**SOLICITATION NUMBER: 2026-27 ADA Ramp Installation Project**  
**Addendum Number: 1**

**Description of Modification to Solicitation:** Addendum 1 Pre-Bid Sign in Sheet, Exhibit A Traffic Sign Support, Mounting, and Hardware Details, Vendor Questions.

**Exhibit A – Traffic Sign Support, Mounting, and Hardware Details**

# Exhibit A

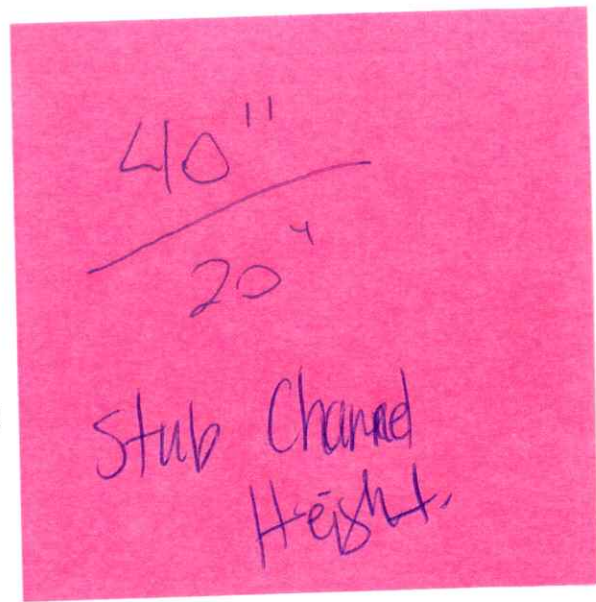
Additional technical requirements for sign supports, conduit sleeves, mounting height, lateral offset, and associated hardware are provided in Exhibit A – Traffic Sign Support, Mounting, and Hardware Details, attached to this Addendum and incorporated herein by reference.

## Sign Channel

- Dip Galvanized
- 2lb/ft
- With standard holes

3"ID conduit sleeve in sidewalk to place channel

**EXISTING CURB AND SIDEWALK REPLACEMENT AND PAYMENT DETAIL**

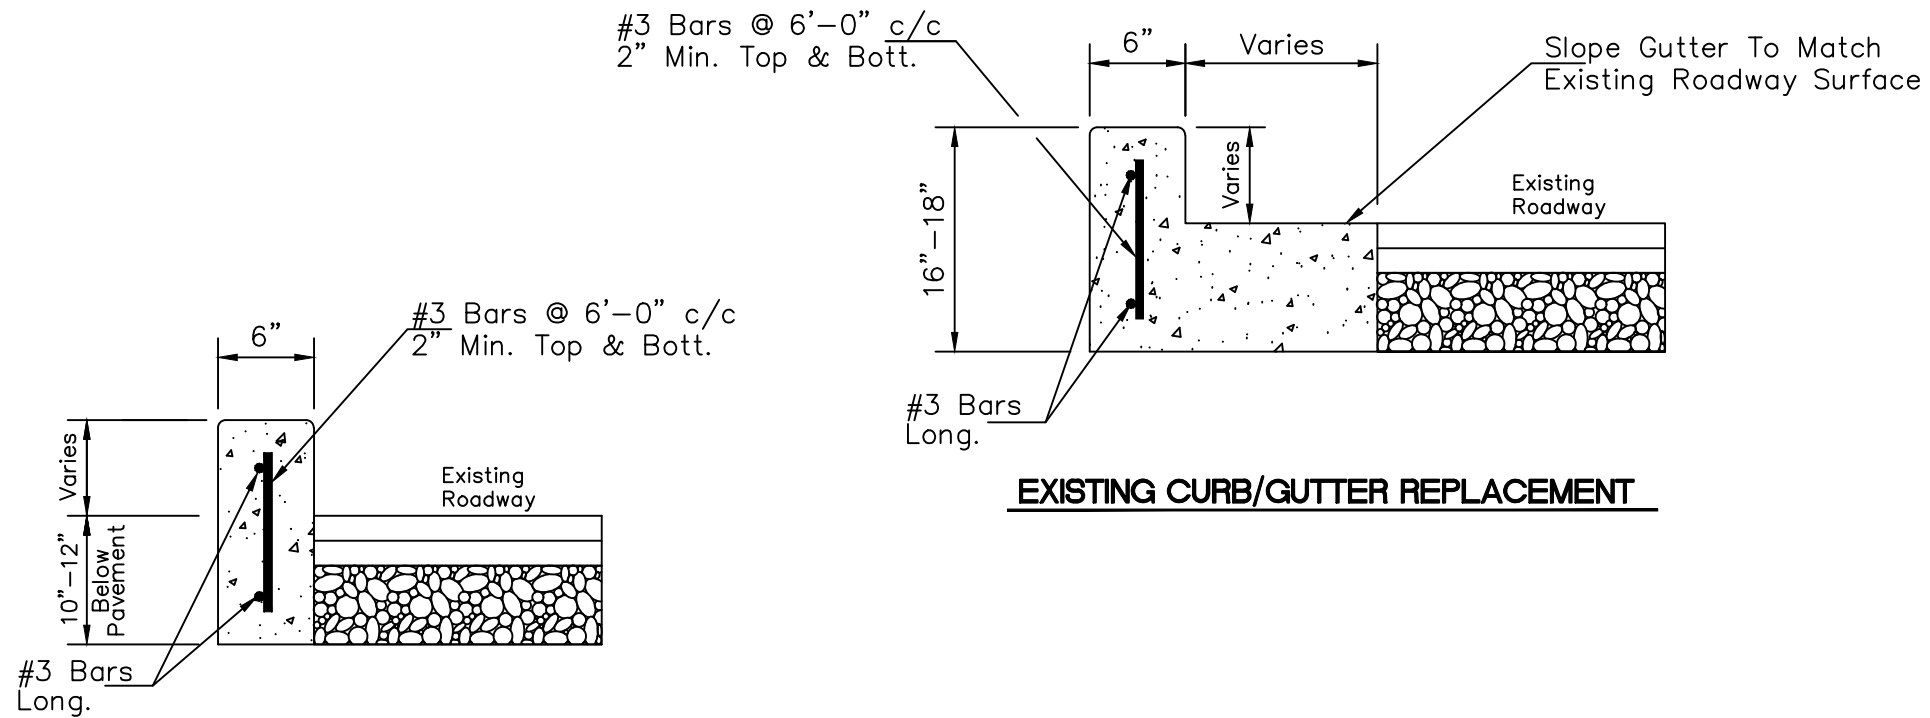
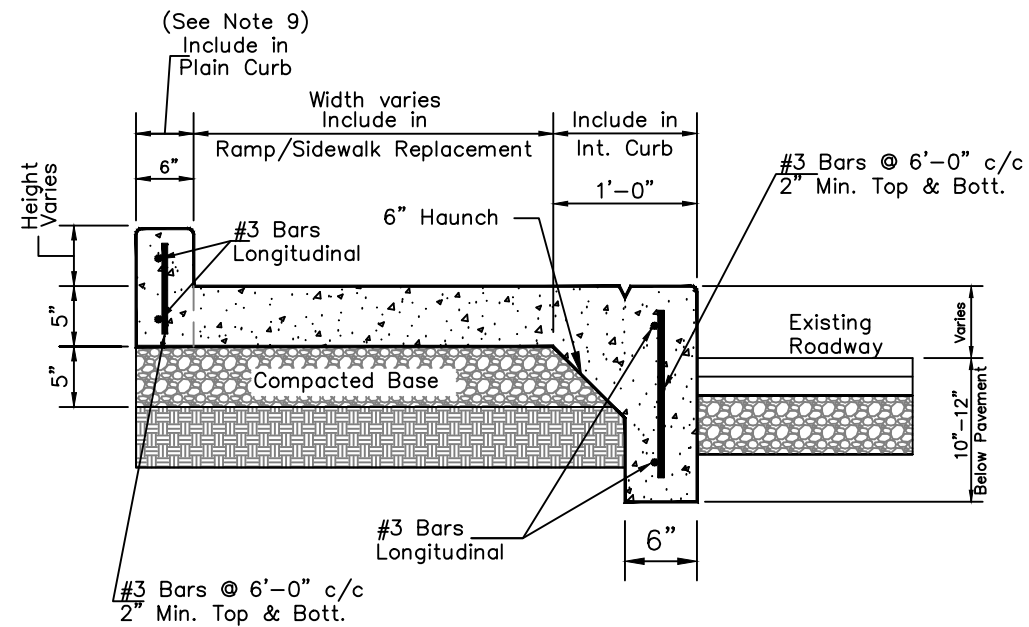
**Q1: It was mentioned in the Prebid regarding #3 rebar. I do not see anything mentioned in the drawings or the detailed plans provided. Can you please direct us to where it will be needed?**

**Q2: Pay Quantities start 1 foot back from the face of curb. This was mentioned in the Prebid meeting and we would like clarification on it.**

A1: See Exhibit B, it shows the rebar location, 2 horizontal #3 rebar and vertical #3 rebar at 6' center to center in the curbs.

A2: See Exhibit B, "Existing Curb and Sidewalk Replacement and Payment Detail", from the face of the 6" curb to the back of the 6" haunch is part of Item 3.03 Integral Curb, this item includes the 6" integral curb and the 6" haunch. The sidewalk payment will start where Item 3.03- Integral Curb ends which is 1 ft from the face of the curb.
